## PIC24FJ256DA210 Family Silicon Errata and Data Sheet Clarification

The PIC24FJ256DA210 Family devices that you have received conform functionally to the current Device Data Sheet (DS39969B), except for the anomalies described in this document.

The following typographic corrections and clarifications are to be noted for the latest version of the device data sheet (DS39969B):

**FIGURE 2-3** FREQUENCY vs. ESR PERFORMANCE FOR SUGGESTED VCAP

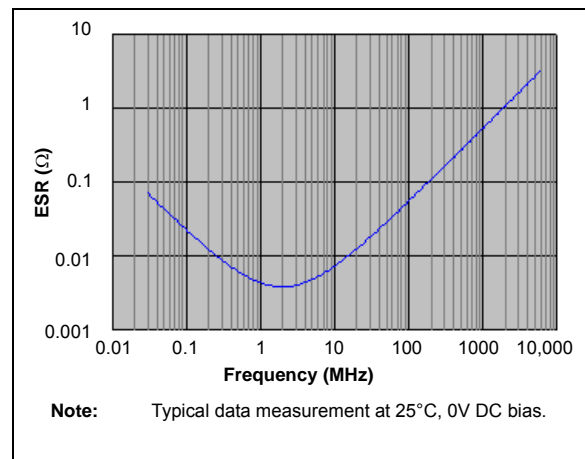
Section 2.4 Voltage Regulator Pins (ENVREG/DISVREG and VCAP/VDDCORE) has been replaced with a new and more detailed section. The entire text follows:

When the regulator is enabled, a low-ESR ( $< 5\Omega$ ) capacitor is required on the VCAP pin to stabilize the voltage regulator output voltage. The VCAP pin must not be connected to VDD and must use a capacitor of  $10\ \mu\text{F}$  connected to ground. The type can be ceramic or tantalum. Suitable examples of capacitors are shown in Table 2-1. Capacitors with equivalent specifications can be used.

Designers may use Figure 2-3 to evaluate ESR equivalence of candidate devices.

The placement of this capacitor should be close to VCAP. It is recommended that the trace length not exceed 0.25 inch (6 mm). Refer to Section 30.0 “Electrical Characteristics” for additional information.

**FIGURE 2-4 DC BIAS VOLTAGE vs. CAPACITANCE CHARACTERISTICS**

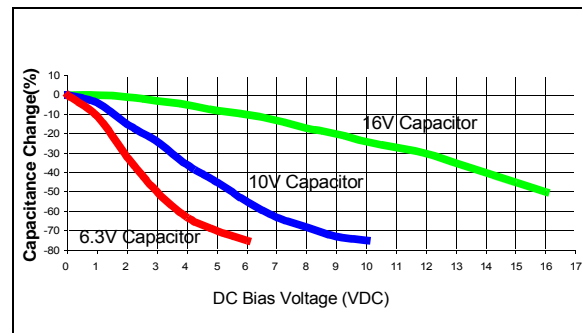
In addition to temperature tolerance, the effective capacitance of large value ceramic capacitors can vary substantially, based on the amount of DC voltage applied to the capacitor. This effect can be very significant, but is often overlooked or is not always documented.

A typical DC bias voltage vs. capacitance graph for 16V, 10V and 6.3V rated capacitors is shown in Figure 2-4.

When selecting a ceramic capacitor to be used with the internal voltage regulator, it is suggested to select a high-voltage rating, so that the operating voltage is a small percentage of the maximum rated capacitor voltage. For example, choose a ceramic capacitor rated at 16V for the 1.8V VCAP voltage. Suggested capacitors are shown in Table 2-1.
